**DIVISION OF RATEPAYER ADVOCATES
CALIFORNIA PUBLIC UTILITIES COMMISSION**

AMENDED
**Report on the
Pipeline Safety Enhancement Plan of
Pacific Gas & Electric Company**

Pipeline Modernization Plan

R.11-02-019

Figure 13 – Results of PG&E QRA analysis for entire PSEP

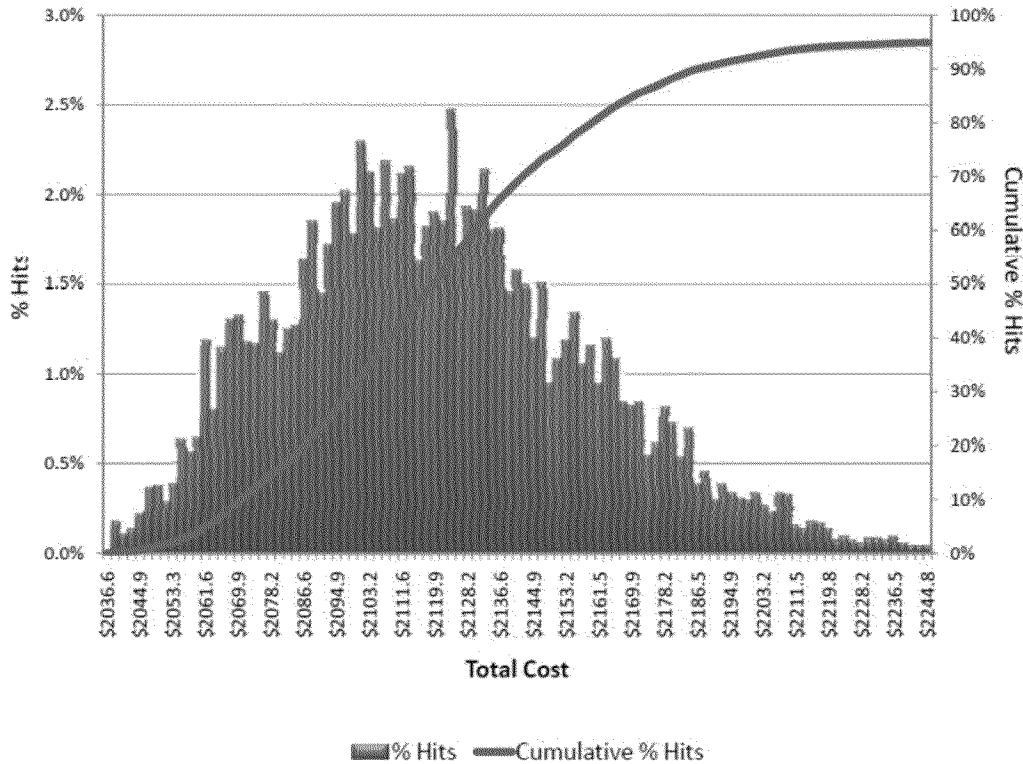
¹⁹⁰ Figure 7-5 in PG&E’s Testimony is incorrect. See PG&E’s response to DRA data request DRA_041-07. A corrected figure was provided in the January 20, 2012 Errata filing, p. 7-42.

1 variability of outcomes over the entire “Range Applied” shown in Table 7-6, the
2 Figure 7-5 would show that there would be a probability of greater than zero (P0)
3 that actual costs will be less than the 2,036.6 million PG&E shows in Figure 7-5.
4 If PG&E were to use the AACE I Classification Range (-30% to +50%) shown in
5 Table 7-6 for Class 4 estimate, it can be argued that the P0 values should be even
6 *less* than the baseline cost of \$1,803.4 million. Given that DRA’s analysis shows
7 PG&E’s baseline cost estimate to be higher than industry averages, the QRA
8 should show a significant probability that actual costs could be lower than the
9 baseline estimate. The histogram shown in Figure 7.5 does not show distribution
10 of outcomes for actual costs on either side of the base estimate as the AACEI
11 range for a Class 4 estimate would indicate. At a minimum, the QRA should show
12 a significant probability that actual costs could be less than PG&E’s current

13 2,036.6 million estimate at P0. It appears as if PG&E tailored its assumptions for
14 the QRA model to obtain a pre-determined level of contingency for the PSEP
15 Pipeline Plan project, rather than using reasonable assumptions to let the QRA
16 model suggest a proper level of contingency.

1 Figure 15 – PSEP Contingency request for pipeline replacement compared to
 2 PG&E QRA results¹⁹³

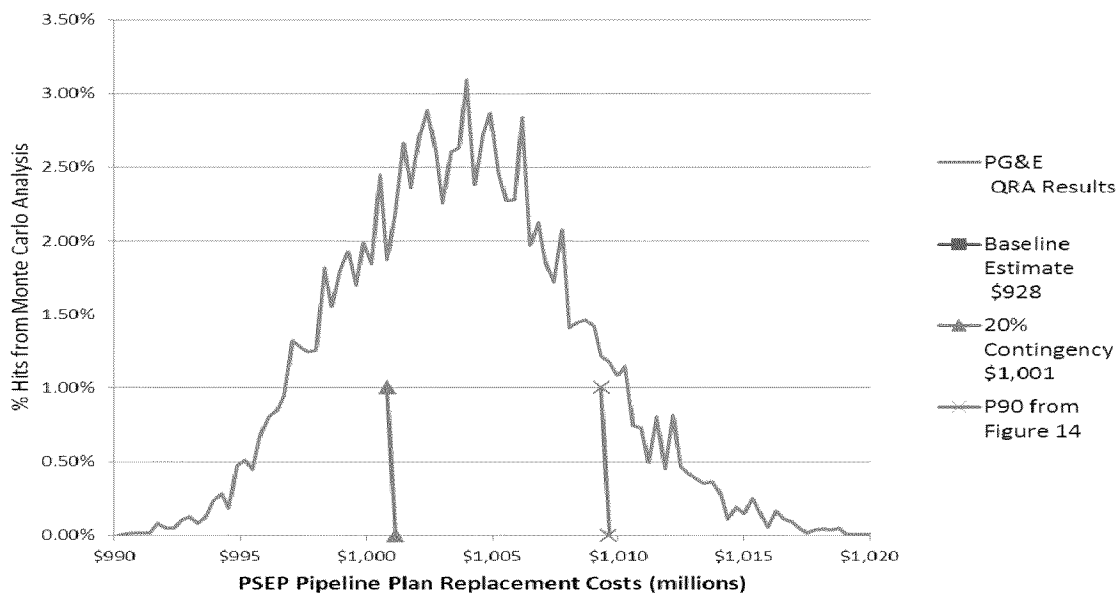
Figure 15 illustrates that PG&E’s QRA provides outcomes roughly centered on the 20% value chosen by PG&E, but skewed to the right (greater probability of higher cost). This figure also illustrates the discrepancy mentioned in footnote XXX of this exhibit, since PG&E’s 20% contingency is supposed to be a P90 value. It is clear from this figure that the 20% contingency is not a P90 value.
